FACPAC Contract Change Order

Tier 1 Project: ECHS Renovation Phase #7

CHANGE ORDER NUMBER: 8-3
INITIATION DATE: 9/26/2022

SUBJECT: PR 26 - Gym Concession Changes and Lobby Flooring - REVISED PROPOSAL REQUEST ID: PR 26

PR26.1

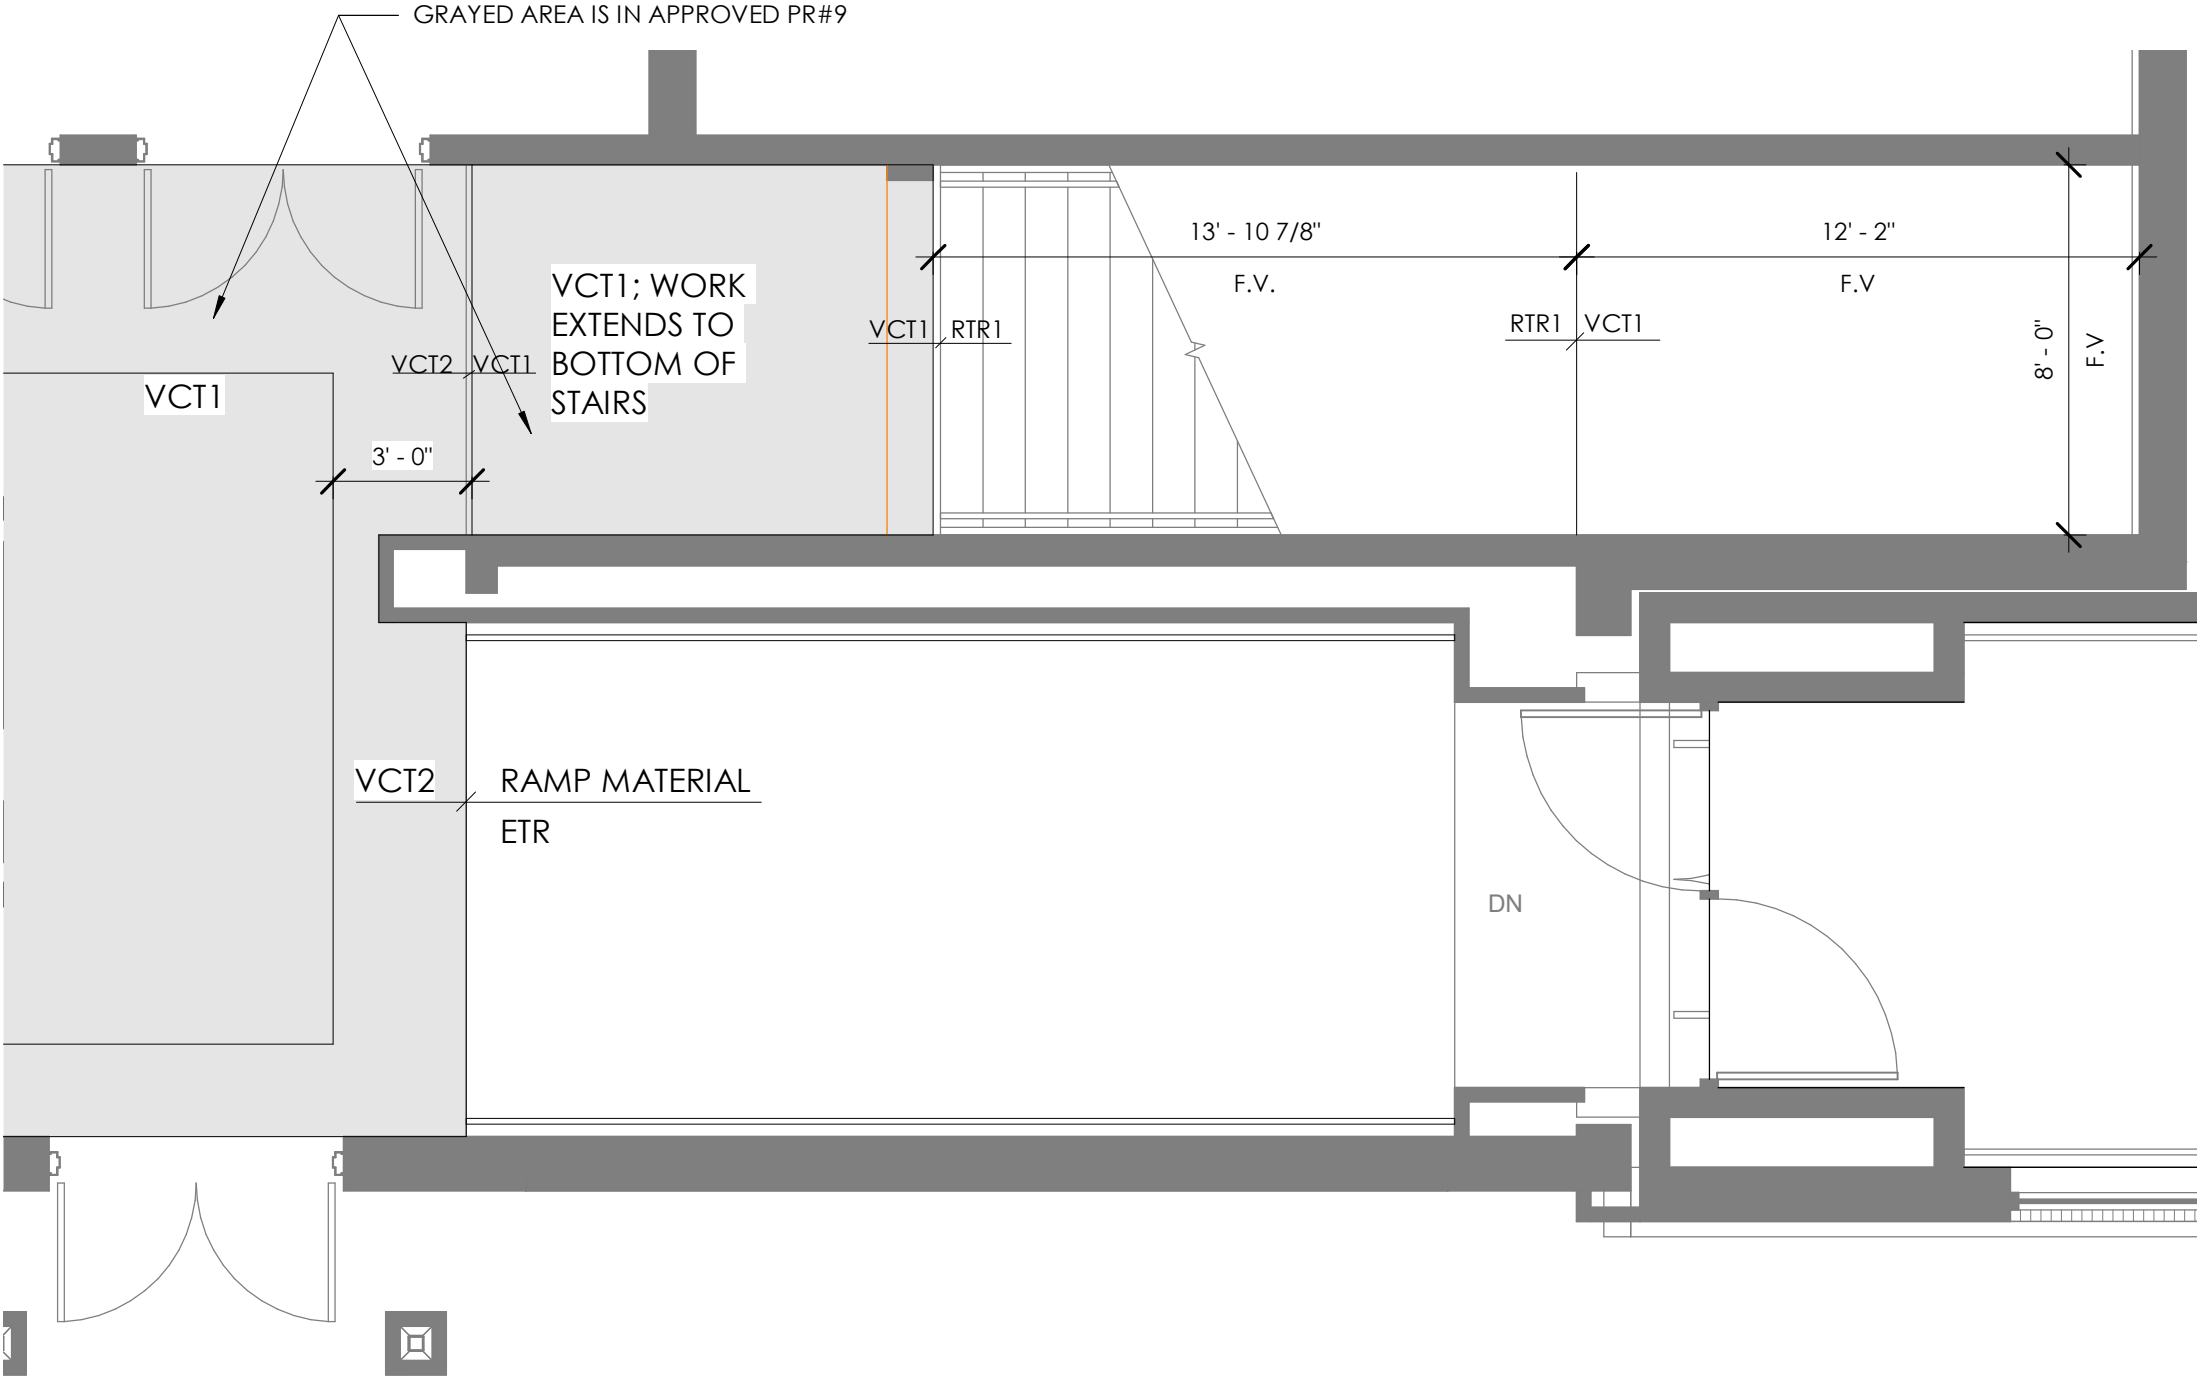
1. Provide VCT1 and Resilient Treads and Risers on the Lobby Stairs and Landing per the drawings.
 - a. Prepare stairs for resilient treads by cleaning floor and stair finishes and sanding metal treads per resilient manufacturer's instruction for new installation, fill gaps at nose of tread with appropriate filler, provide no seams in treads. Provide VCT1 at top of landing with 2 coats of wax.
2. Provide separate price for updates to casework and a small area of additional FRP per drawings. Include deduct for one base cabinet originally in PR9 that has now been removed. Countertop shall be stainless steel and cabinets shall be plastic laminate.

MODIFICATION AT STAIR TREADS AND RISERS: Remove existing VCT at treads. Prepare stairs by cleaning floor and stair finishes to remove all loose soil and contaminants. Metal nosing shall remain intact and in place.

1. Provide RT1 Tarkett 1314 White/Gray at stair risers.
2. Provide RT1 Tarkett 1314 White/Gray at landings

3. Paint stair risers. Farrell Calhoun 0529 Black Licorice (black)
4. Provide two coats of wax at VCT.

INTERIOR ELEVATION - NORTH
1/4" = 1'-0"

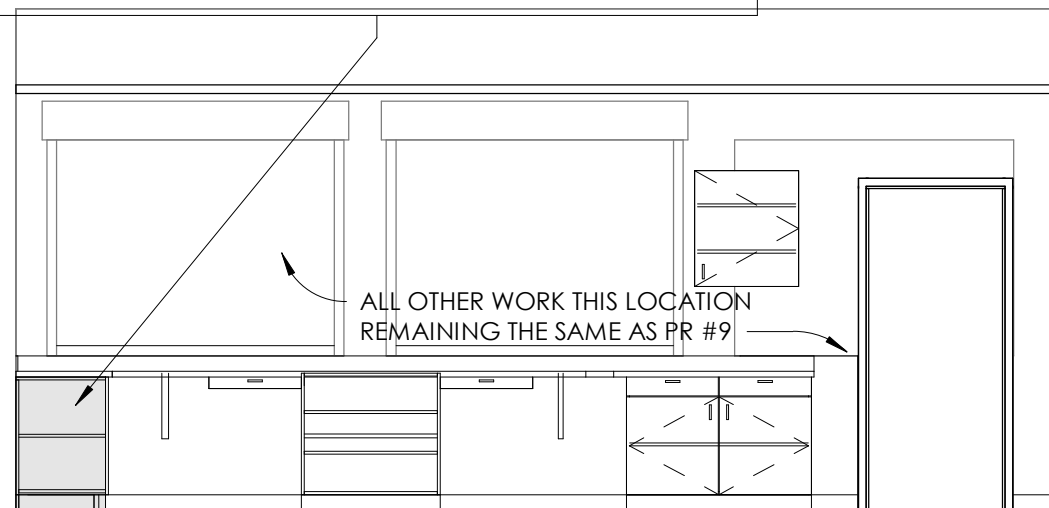
NOTE: BASE CABINET FROM PR#9 PLAN NORTH IN THIS LOCATION HAS BEEN DELETED; AND COUNTERTOP HAS BEEN MODIFIED
